Invitation for Bid: IFB-06-ENG-2026

Project: Hagåtña Wastewater Treatment Plant Rehabilitation
GWA Project No. 22004

Addendum No.: **02**

Hagåtña Wastewater Treatment Plant Site Procurement Report (Addendum A)

Backflow Preventor

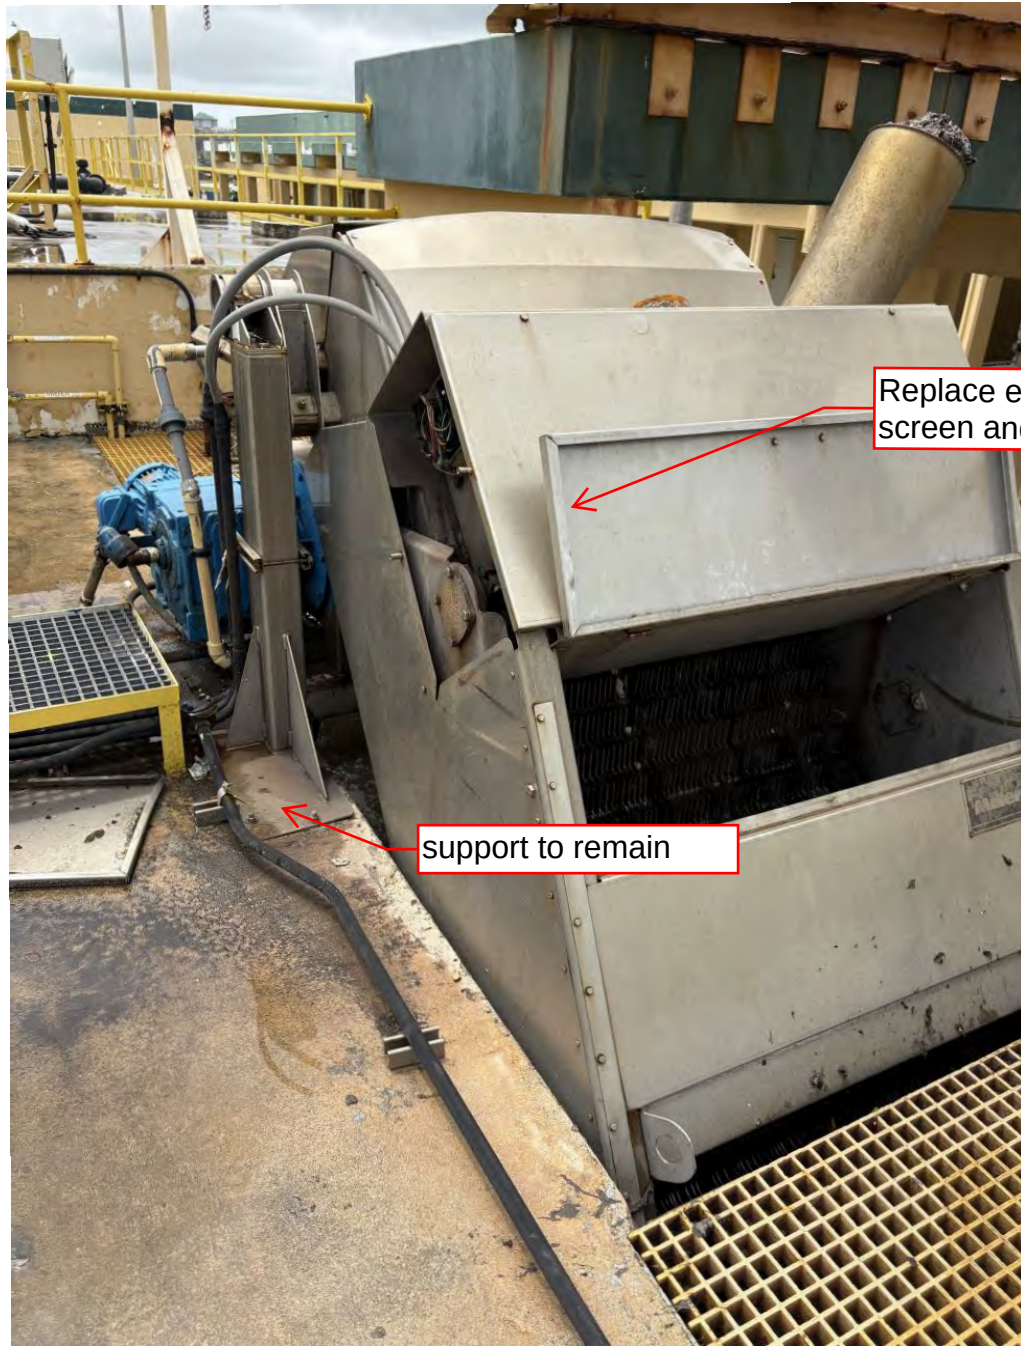
- 2. Recommendation: **(Procurement)**
 - a. Replace the existing 6-inch reduced pressure backflow preventer in kind. Existing flow meter to remain.
 - b. See Sheet C-4.
 - c. See Specification 400567.13

Step-screen

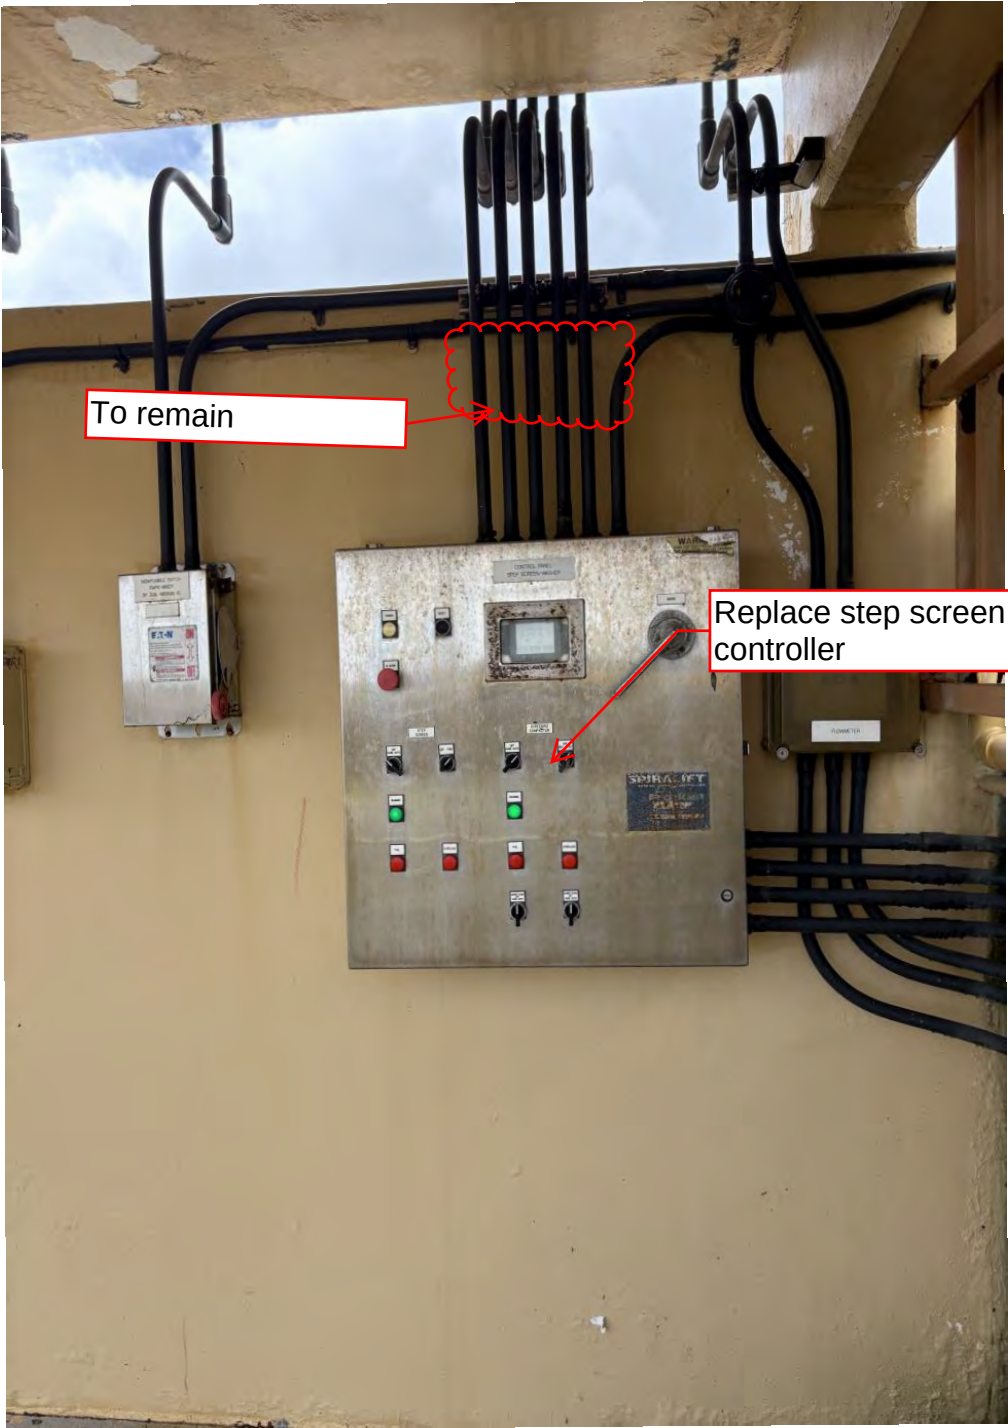
- 2. Recommendation (**Procurement Package**)
 - a. Mechanical:
 - i. Replace the existing step screen with new screen.
 - ii. Consider will be given to replace the step screen with an alternate system such as a rotating drum screen.

- i. Replace the existing control panel with a new, vendor-supplied packaged panel.
 - ii. Provide a local control station with Operator Interface Terminal (OIT). Install the new packaged PLC in weatherproof enclosure mounted adjacent to the influent channel.
 - iii. Install an ethernet connection from the packaged PLC to the new Master PLC in the Operations Building.
- c. Drawings – The step screens are shown on the civil and electrical drawings (C-1, C-6, C-7, C-8, C-9, E-7, and E-13).
- d. Specification Section 113300 Step Screen and 113310 Screenings Washer

Clarifiers

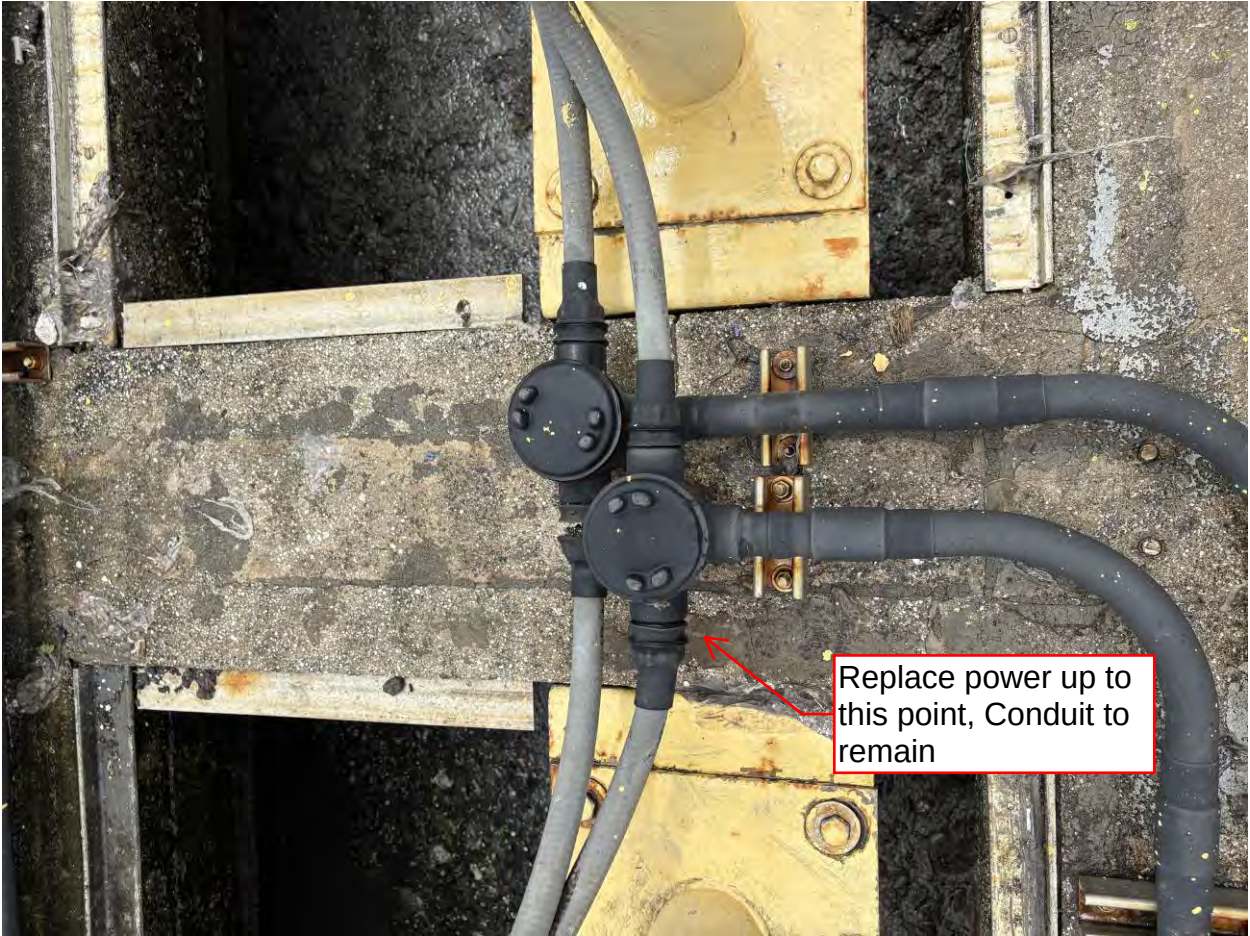
Replace all sludge collectors and motors. Supports to remain

- iii. Reference NFPA 820-2024, Table 5.2.2 Rows 7a and 7c.
- 2. Recommendation
 - a. Mechanical (**Procurement**)
 - i. Replace all three of the cross-collector systems in their entirety with new motors, drive sprockets, chain and flights and scum collector.

- iii. Reference NFPA 820-2024, Table 5.2.2 Rows 7a and 7c.
2. Recommendation
- a. Mechanical (**Procurement**)
 - i. Replace all six of the longitudinal sludge collector systems in their entirety with new motors, drive sprockets, chain and flights.

Primary sludge pump/grinder

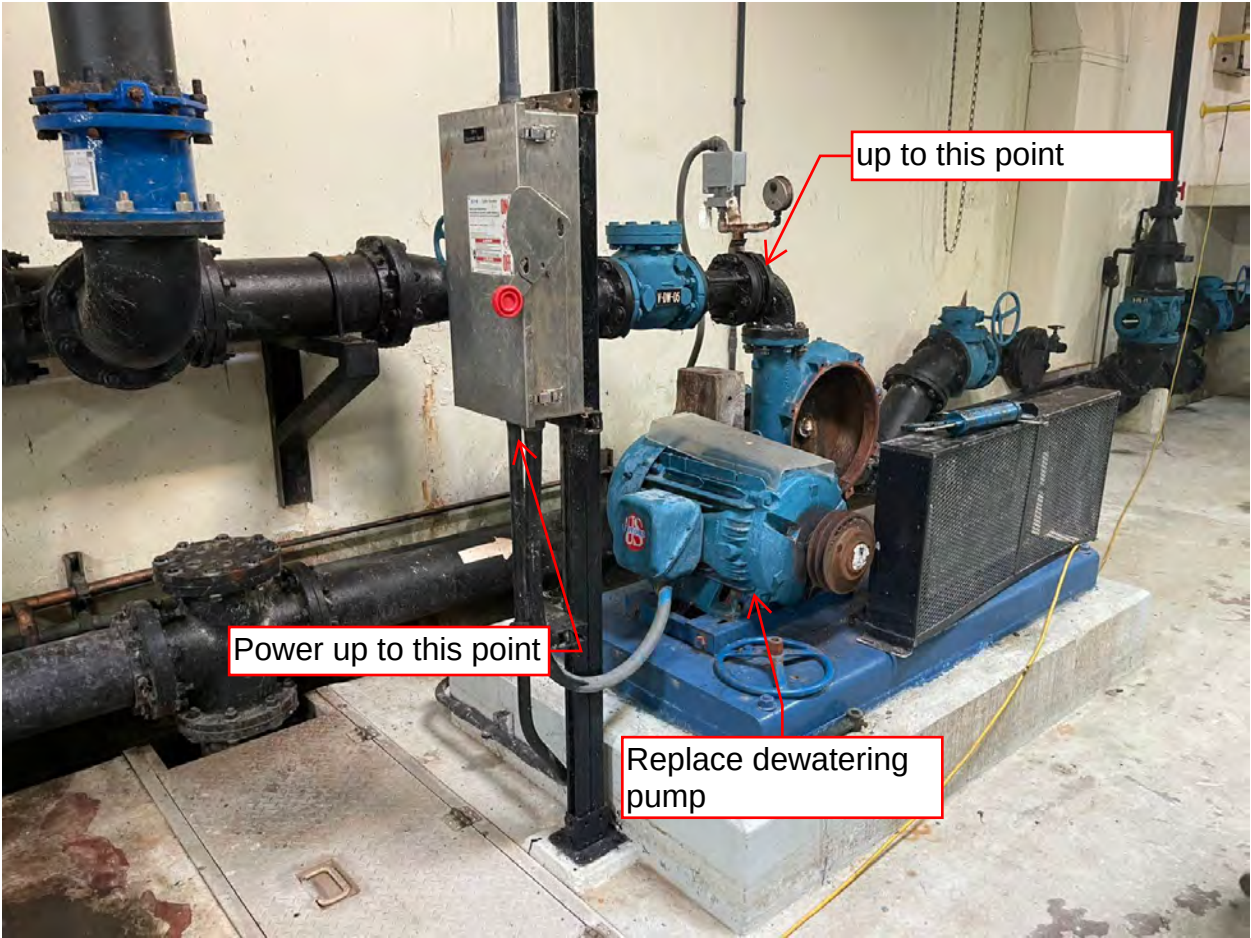
Replace primary sludge pump and grinder up to this point
